Appendix M

Responses to submissions related to the
east-west public access road

Figure M.1 Road configuration showing possible right hand turning lane

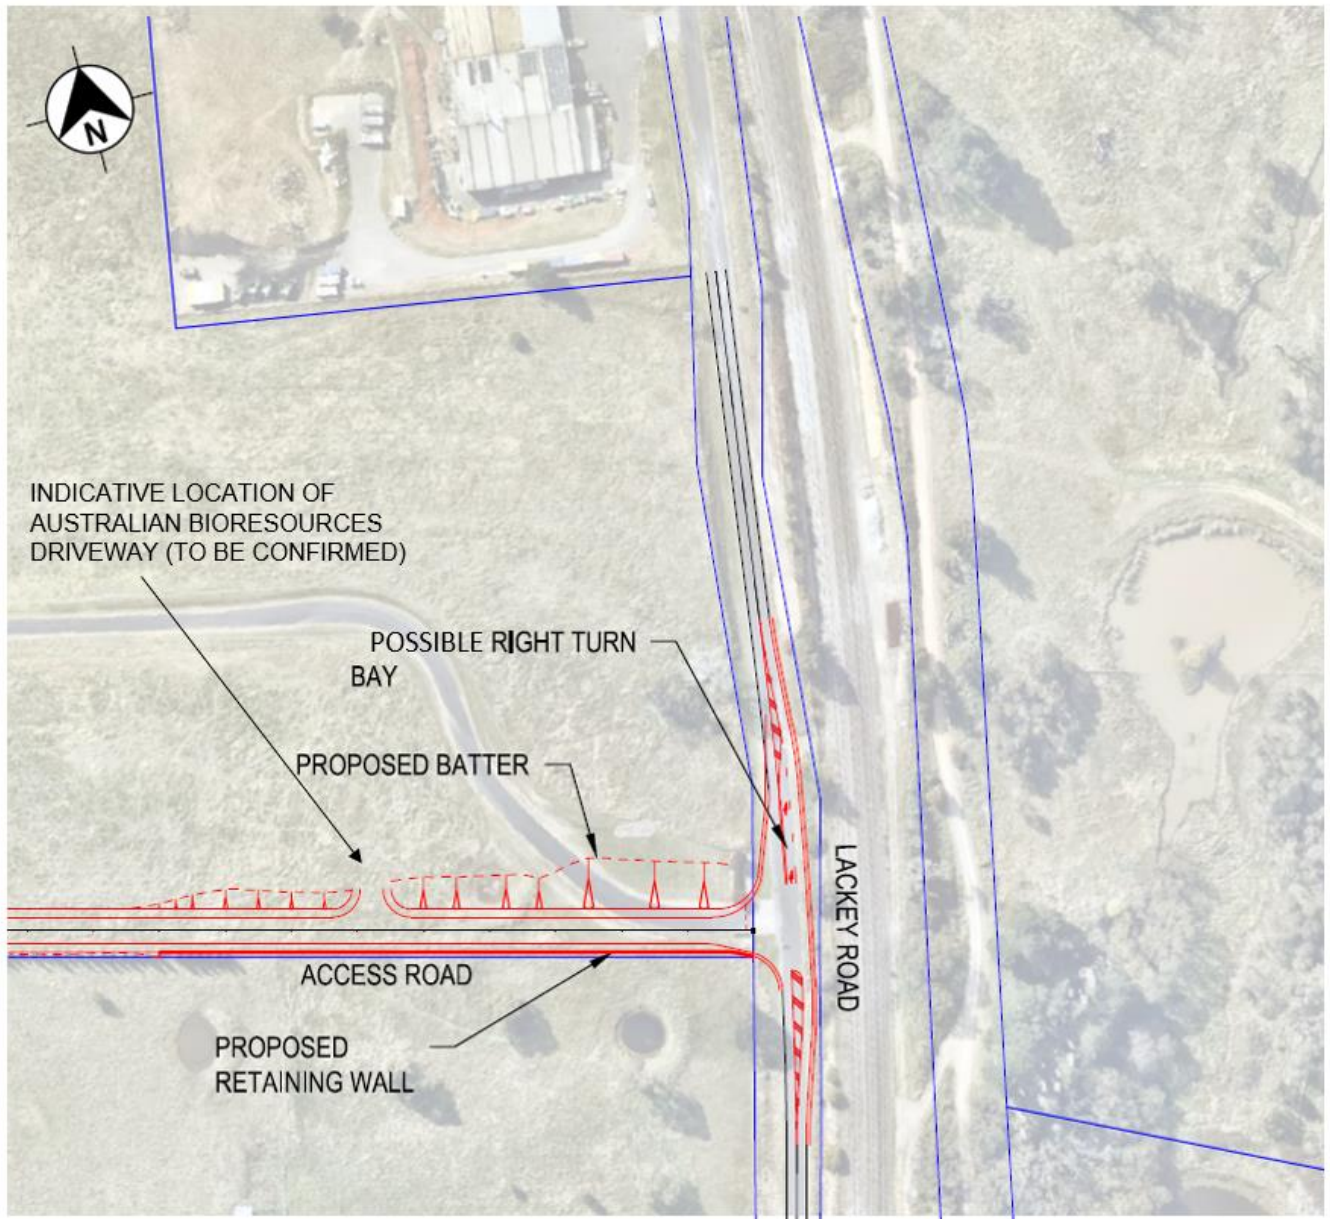
Please provide additional design detail for the proposed access road, particularly the intersection treatment for the intersection with Lackey Road. The design will need to include all road infrastructure improvements required and demonstrate the proposed vehicles can safely use the access road and intersection. Any proposed design also needs to demonstrate the relevant roads authority is satisfied with the proposed design.

A preliminary assessment of sight distances was undertaken, and further analysis during detailed design was also proposed to be undertaken to ensure that adequate sight distance is provided from the crest to the north of the intersection to vehicles waiting to turn right onto the east-west public access road.

If required to improve sight distances, it was identified that a grade correction of Lackey Road could be undertaken to raise the road level to tie in with the new public east-west access road. The intersection upgrade works would cover an approximate 60 metre length of Lackey Road. A dedicated right turn lane could also be provided for southbound vehicles turning into the new east-west public access road. This would improve safety and intersection performance, by ensuring that through travelling vehicles can pass vehicles waiting to turn. Figure K.1 shows a possible future arrangement for the upgraded intersection, if a dedicated right hand turning lane was to be required.

"In response to the preliminary drawings of the intersection of the east-west access road and Lackey Road, the provision of a CHR(S) appears to be an appropriate treatment however final support would be contingent upon receipt of a design report providing confirmation of its adherence to relevant standards and guidelines."
